## Architectural Review Board Staff Report

**Meeting Date:** August 12, 2021

**Location:** 18491 Outlet Blvd.

**Description:** **Chesterfield Blue Valley, Lot 1H ASDSP:** An Amended Site Development Section Plan, Landscape Plan, Lighting Plan, Tree Stand Delineation, Tree Preservation Plan, Architectural Elevations and Architectural Statement of Design for a 6.01-acre tract of land located along the east side of Outlet Boulevard, north of its intersection with Olive Street Road.

Figure 4: Bollard Fencing Detail

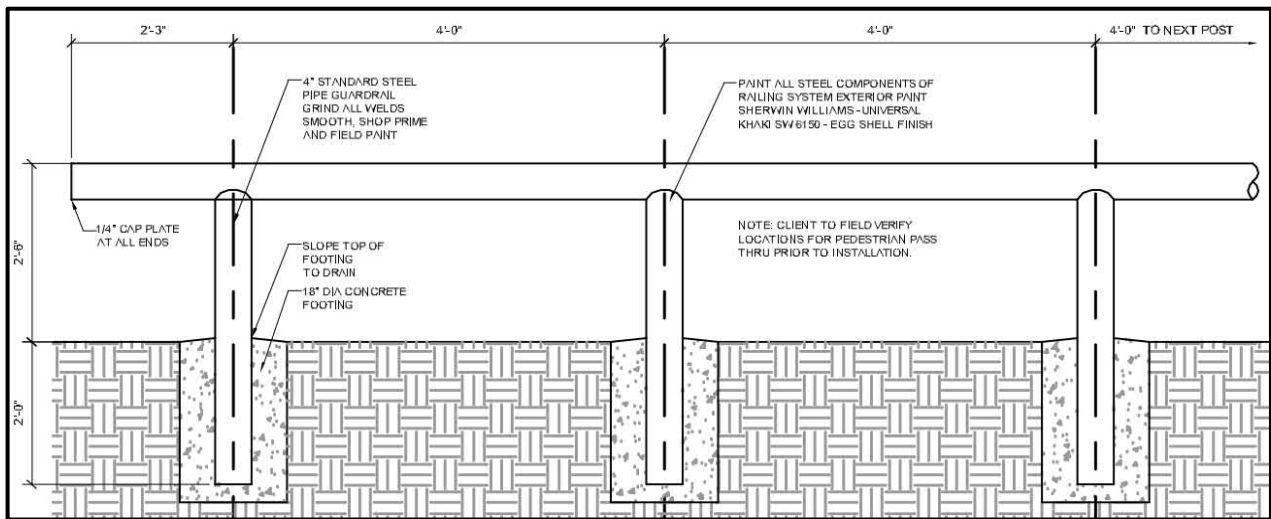
A 2'6" bollard fence will surround a large portion of the site's parking area with gated access to this lot on the northeast side facing the building's main entrance. These gates measure between 4'6" and 6'0" in height and will be non-illuminated. The existing west access points will be closed with landscaped curbed areas with bollards running across. This bollard fencing is located as identified by pink hatching shown in Figure 3 above. A photo example of this bollard fencing is included in the ARB packet. The two (2) gates entering this inventory parking area will stand 6'0" at their highest point and will not be illuminated. A photo example of this gate and a detail are both found in the ARB packet as well.

*The proposed bollard fencing is not outlined in Chesterfield Blue Valley's Design Package and is not found elsewhere in the subdivision.*

Figure 7: Screening Wall / Northeast Elevation

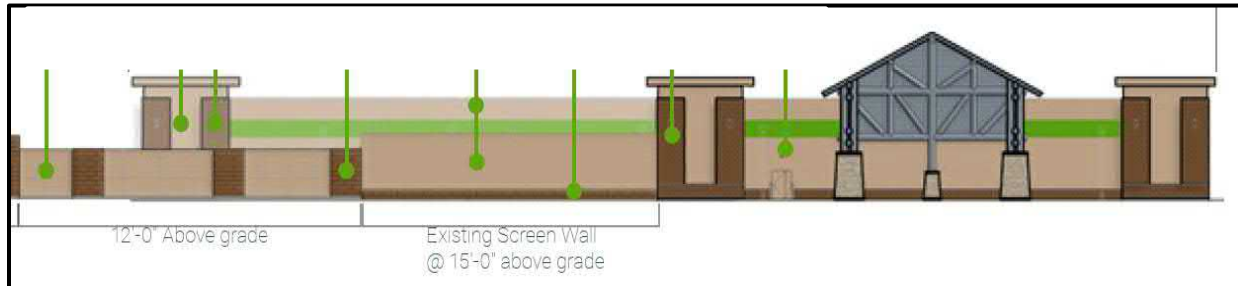
While this screening wall runs across both Lots 1G and 1H, Figure 7 only details the screening wall as it appears on Lot 1H. Figure 8 depicts the screening wall across both lots in its entirety.

The existing screening wall on the northeast elevation is comprised of tilt-up concrete paneling with stucco finish and brick veneer. The proposed addition of the screening wall will be comprised of Cement Masonry Units (CMU) with stucco and brick-patterned EIFS.
